AGENDA CITY OF SALIDA PLANNING COMMISSION

1. Major Impact Review – River Ridge Major Subdivision - The request is for Major Impact Review of a Major Subdivision for River Ridge Subdivision consisting of 41 lots on 9.06 acres located on Scott Street, 500 feet north of CR 105 (Old Stage Road). The property is zoned R-3 and R-4.

PLANNING COMMISSION STAFF REPORT

RE: River Ridge Subdivision Plan review comments

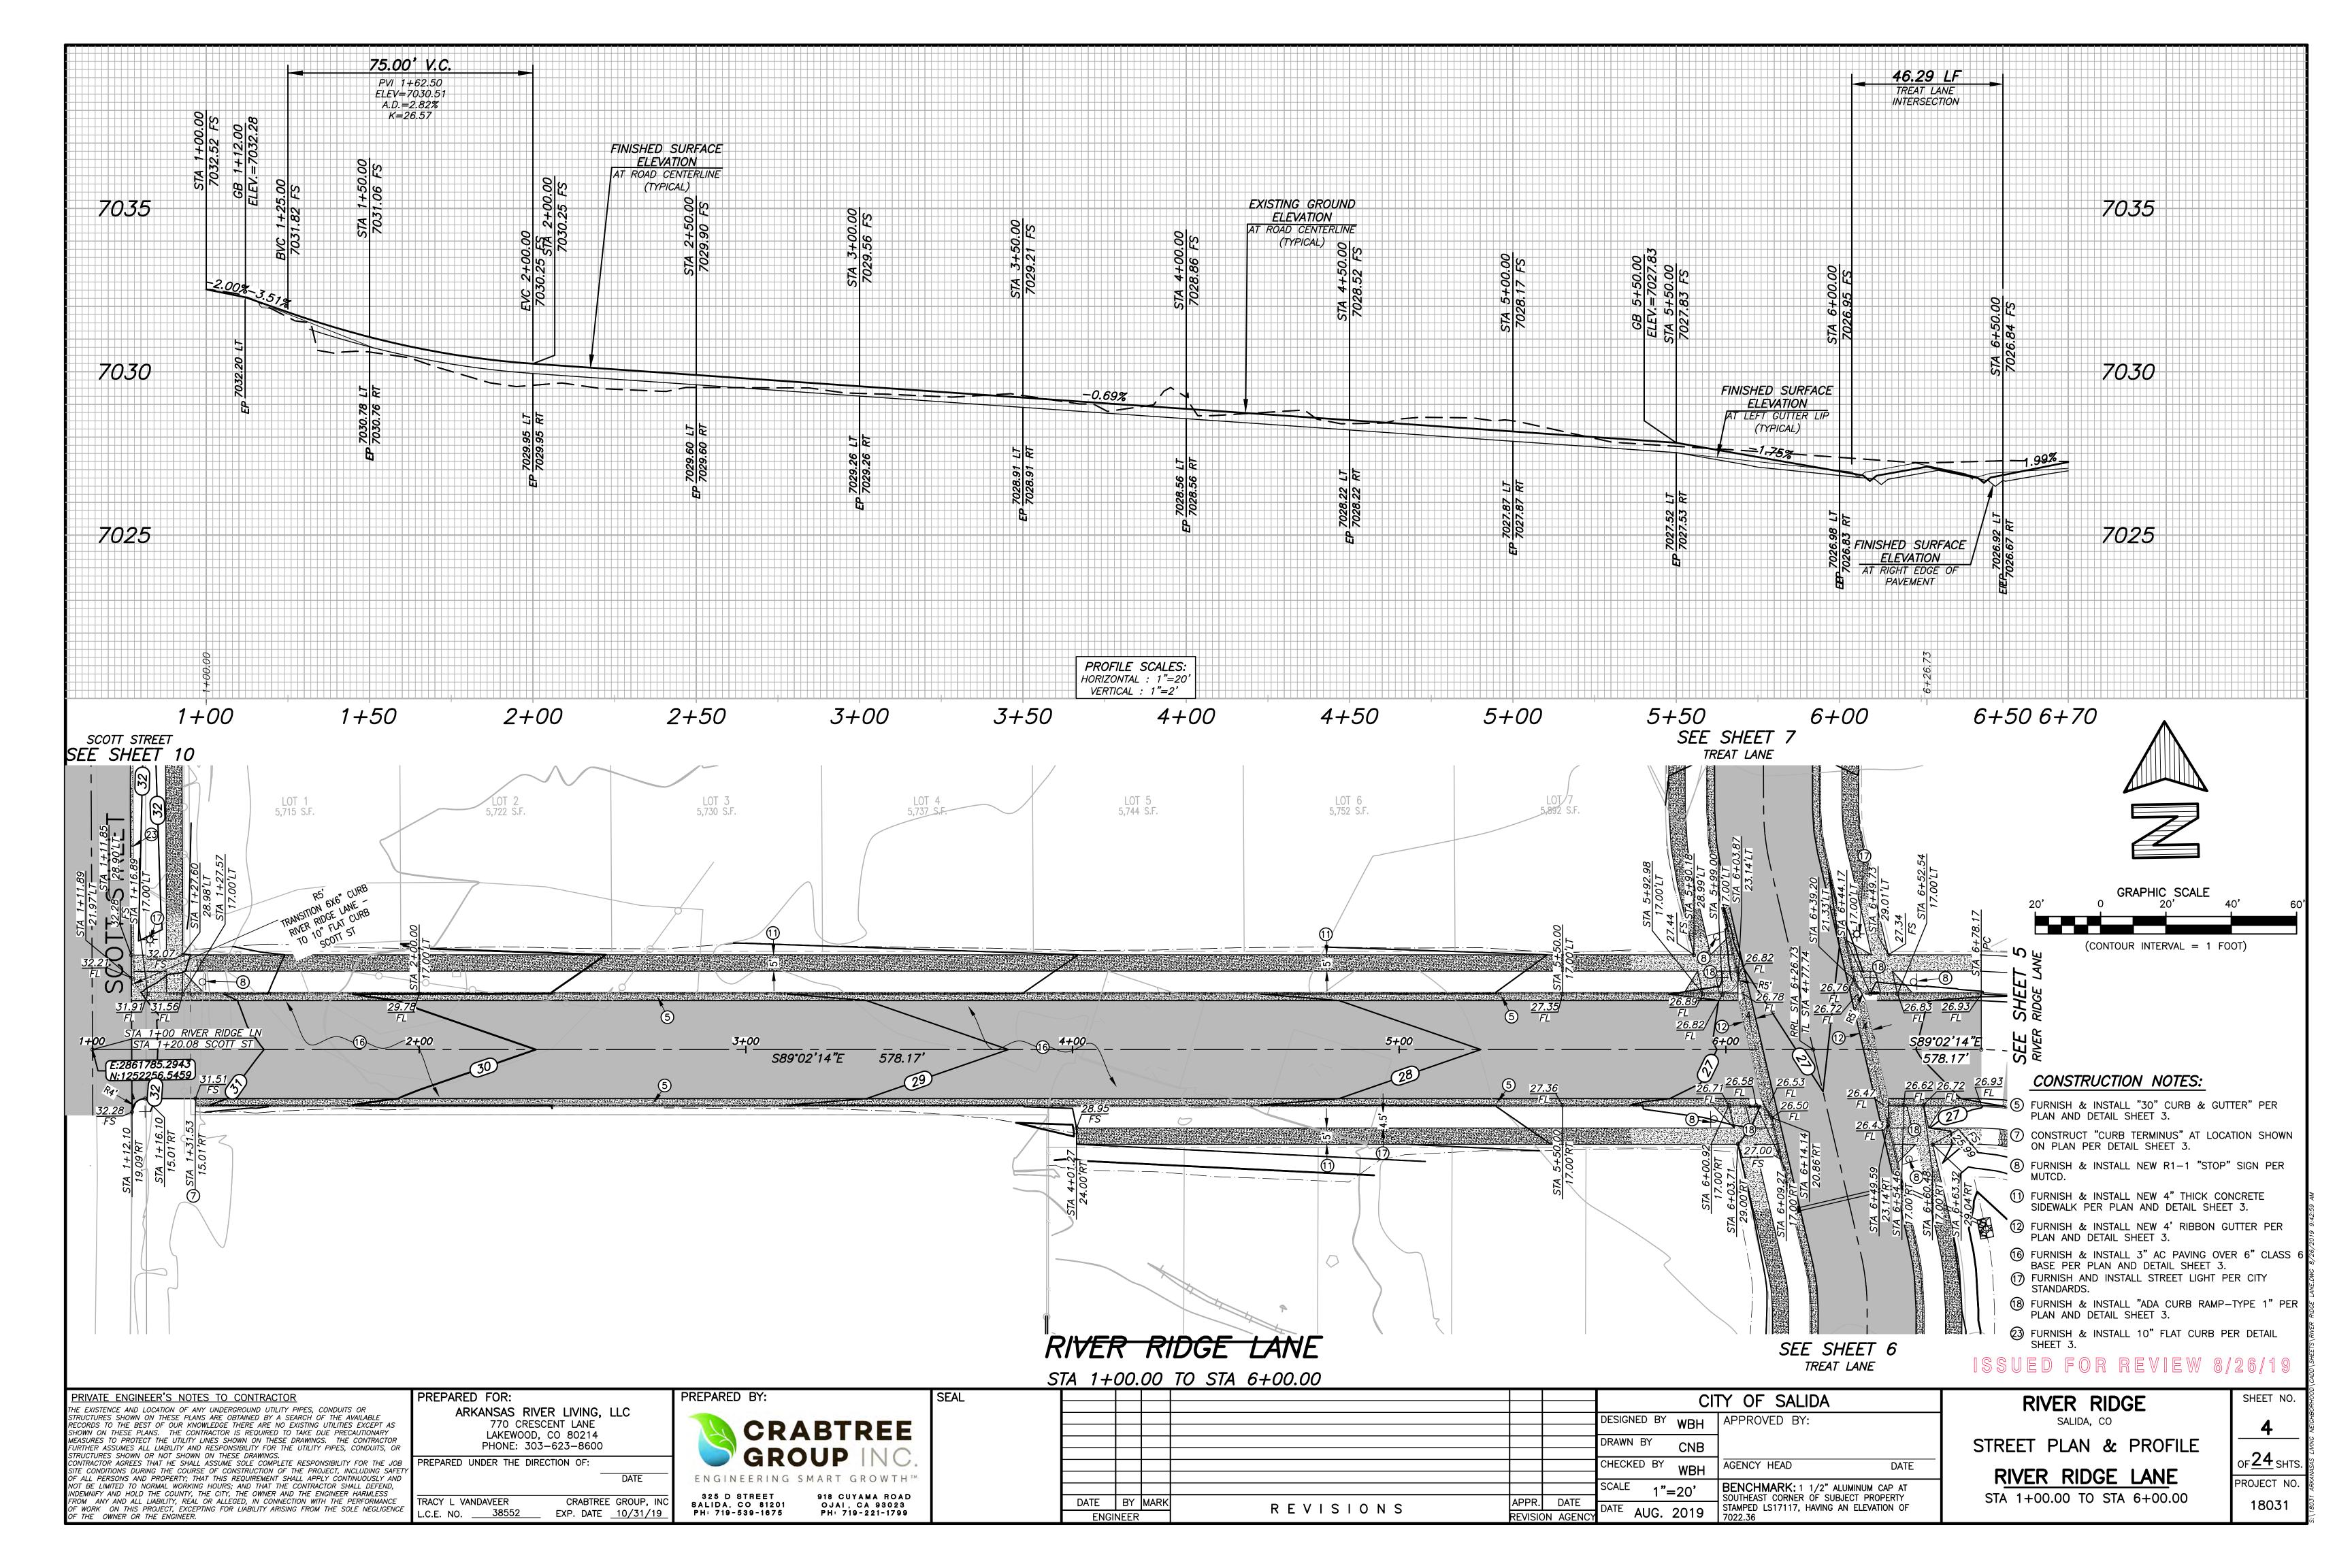
- 3. Sheet numbers on street index sheet (SH-2) need corrected.
- 4. The street details (SH-3) need corrected to match the City of Salida's standard street sections. Insert City of Salida standards detail sheets.

STREET PLAN & PROFILE

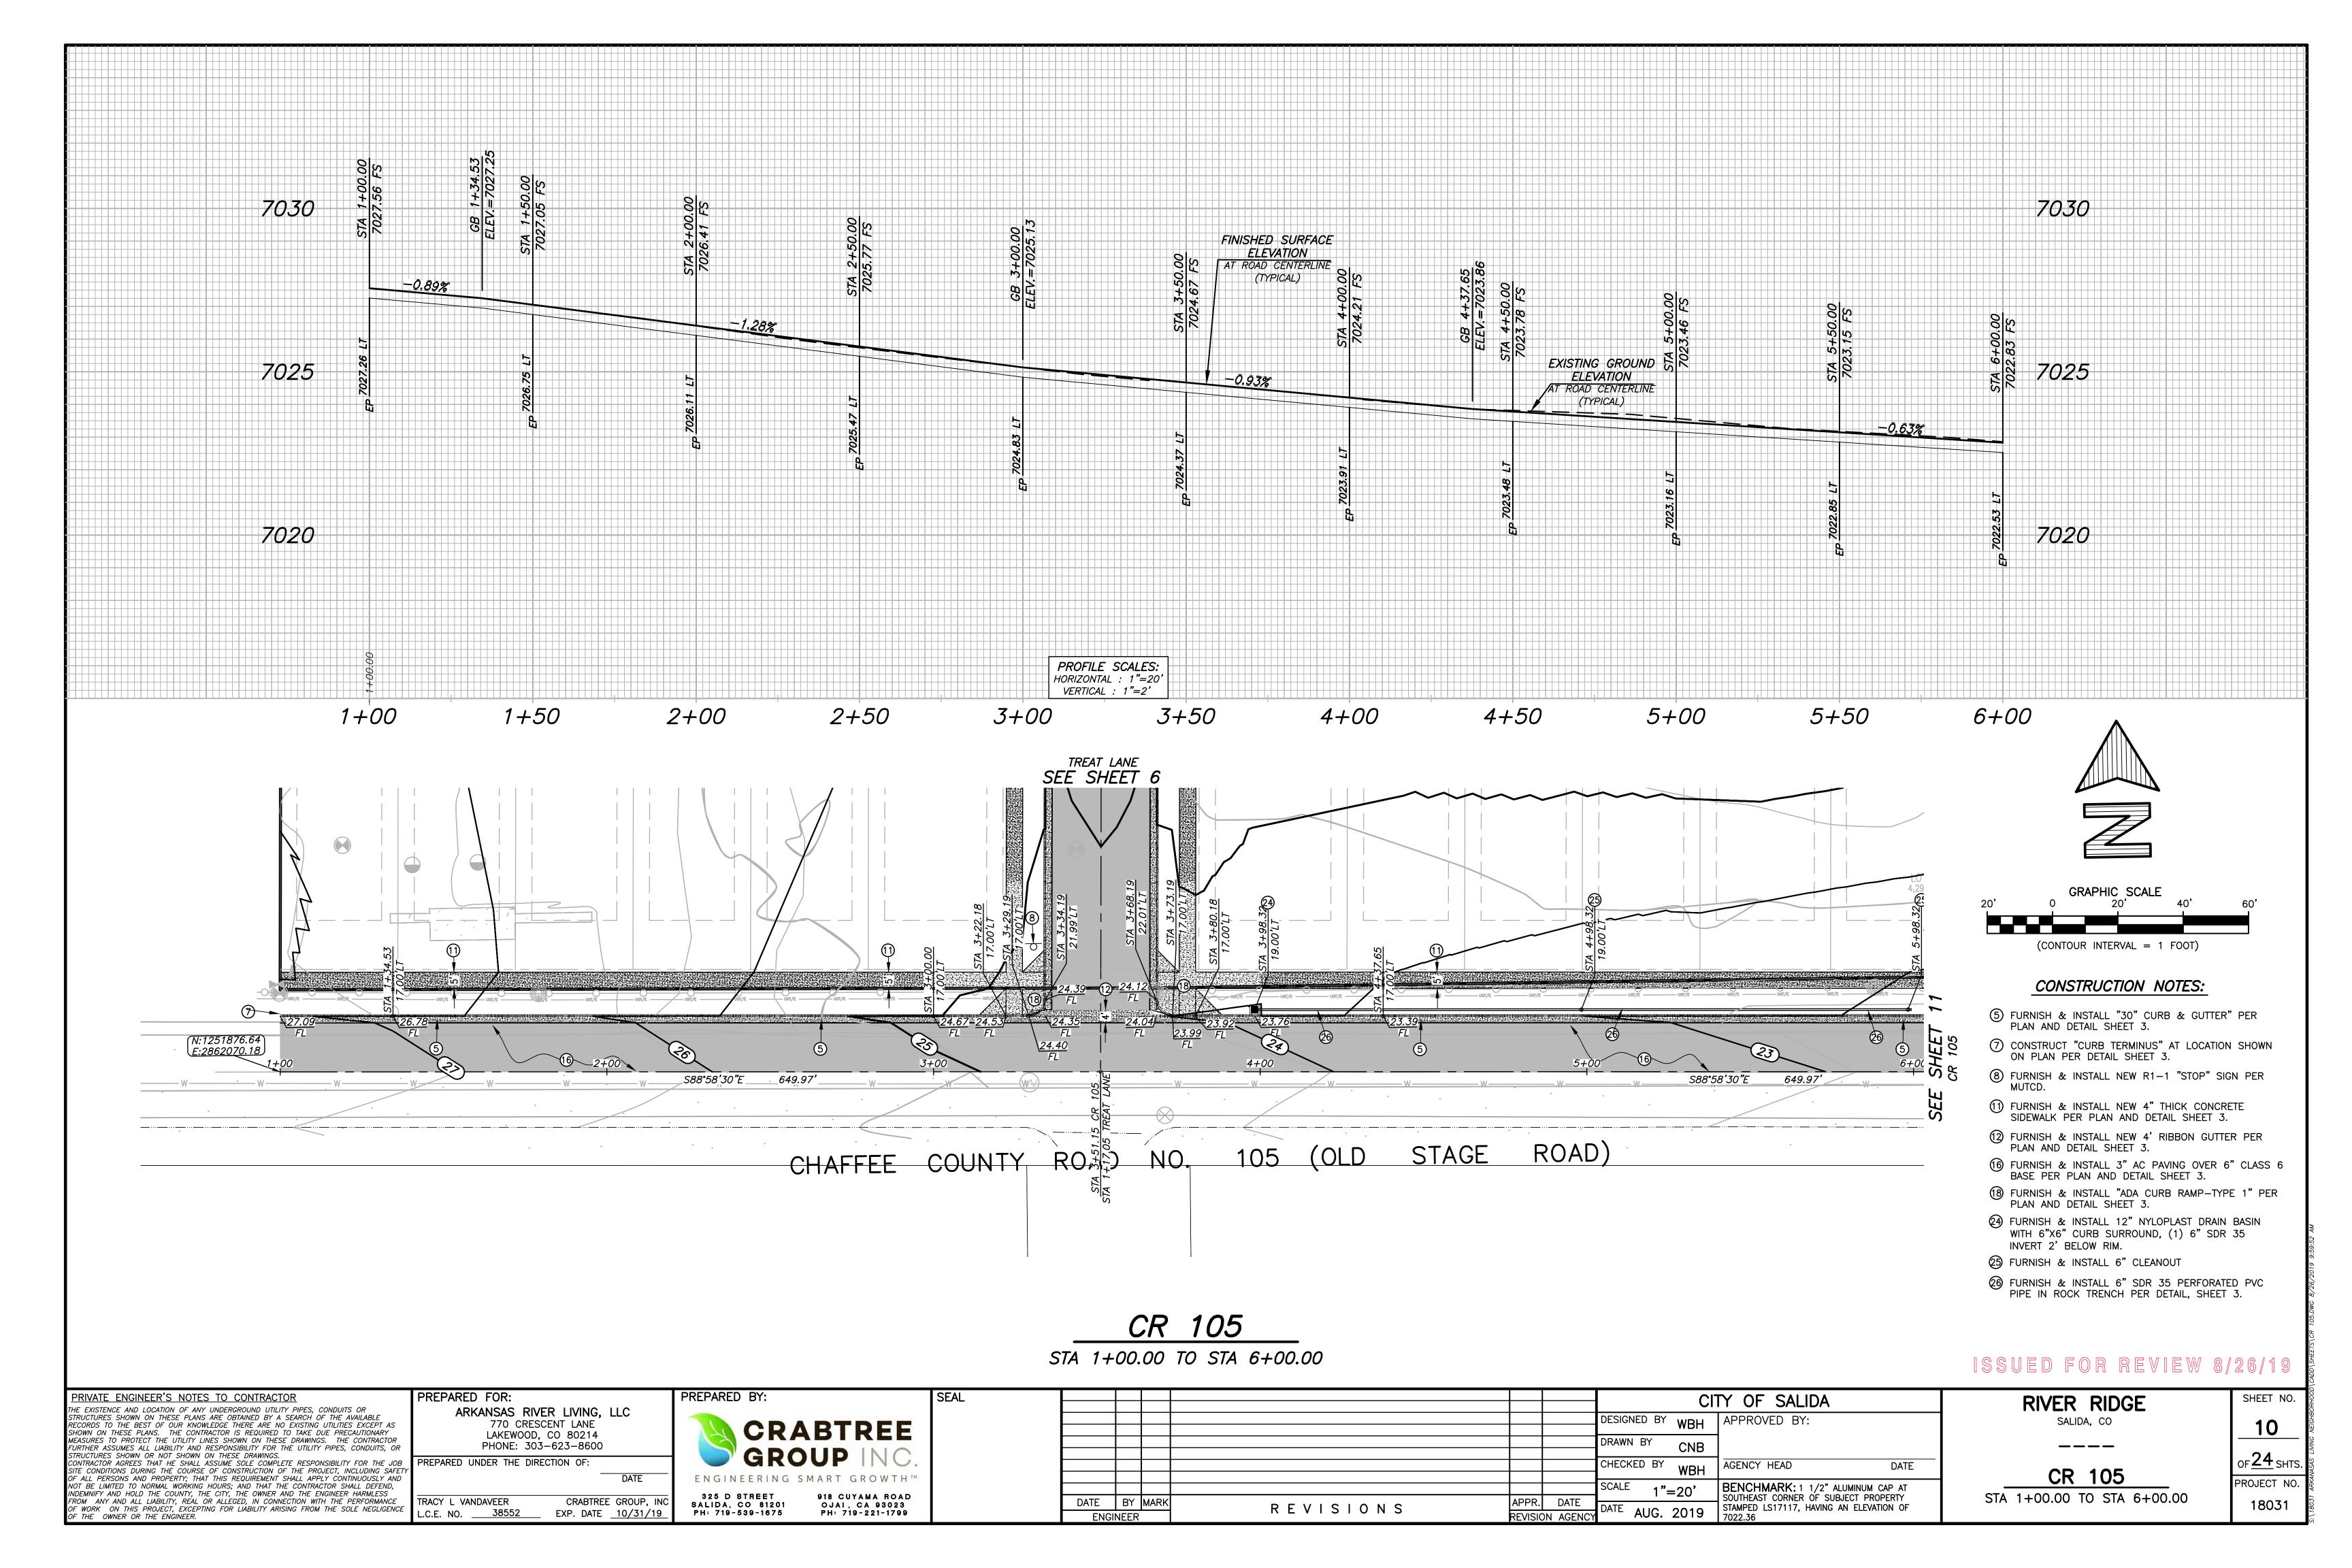
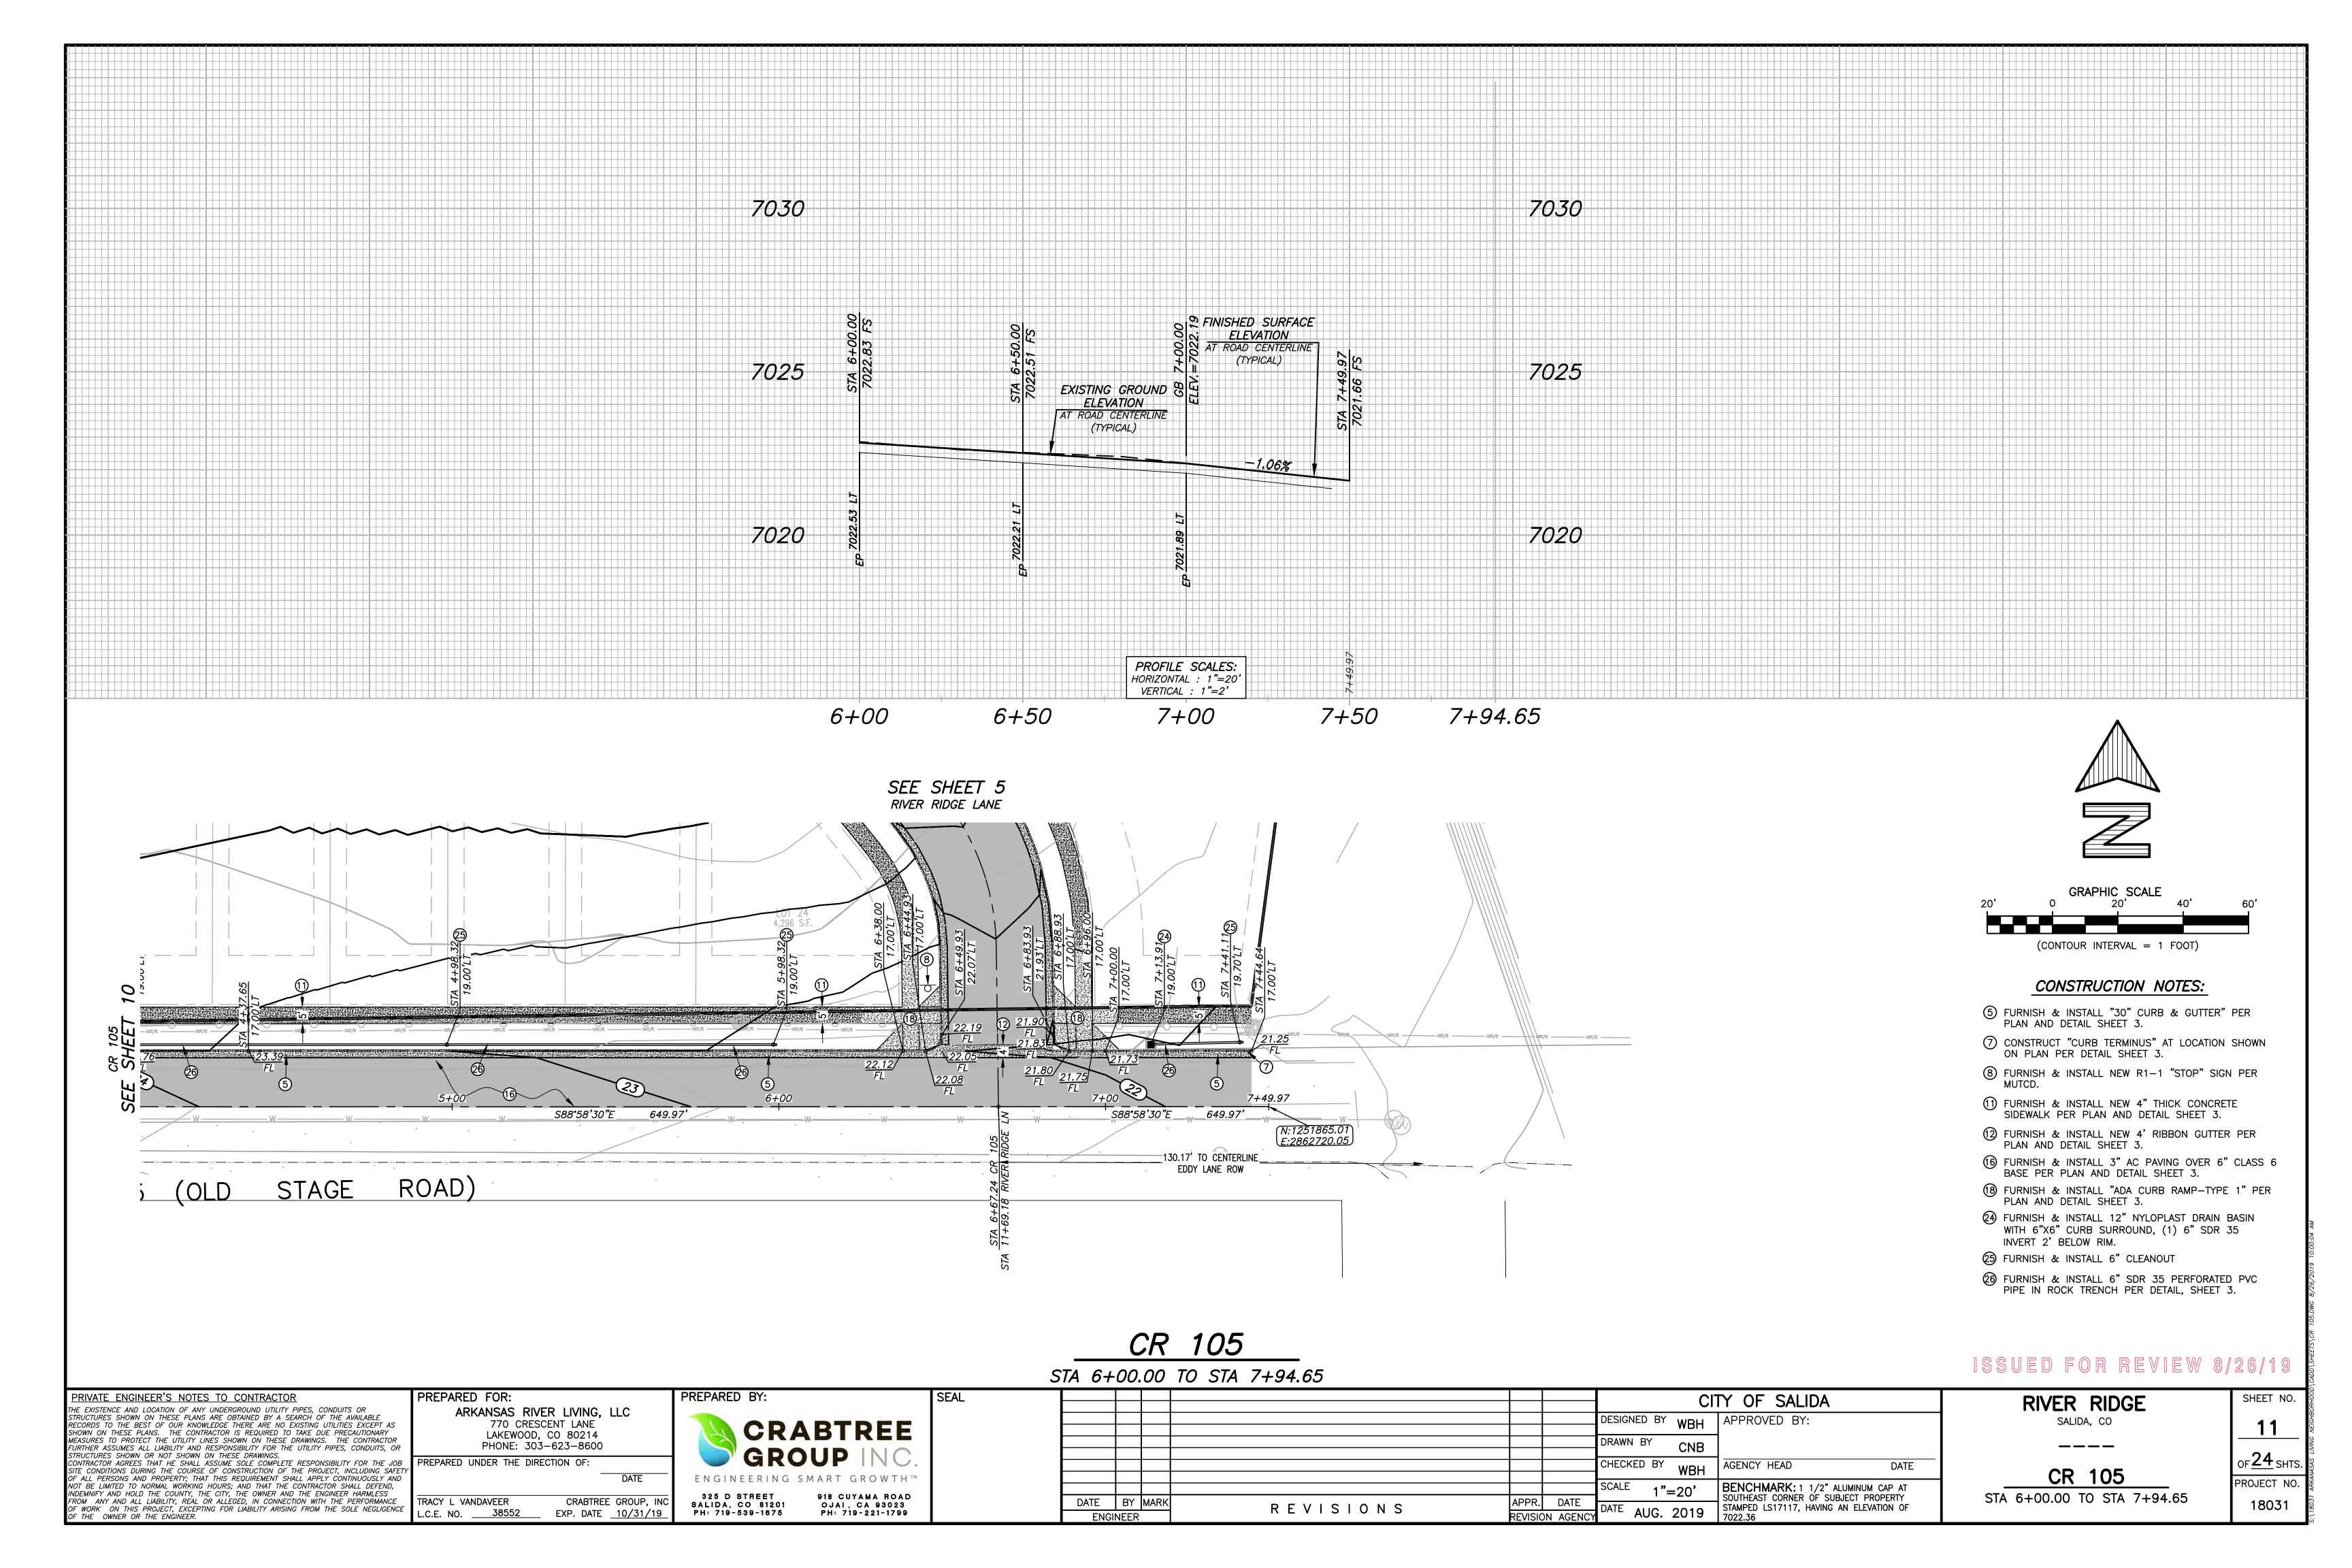
- 6. Provide 15-ft radius at the west side of the Scott St. and River Ridge Lane intersection and terminate vertical curb and gutter with a 6-ft taper (SH-4).
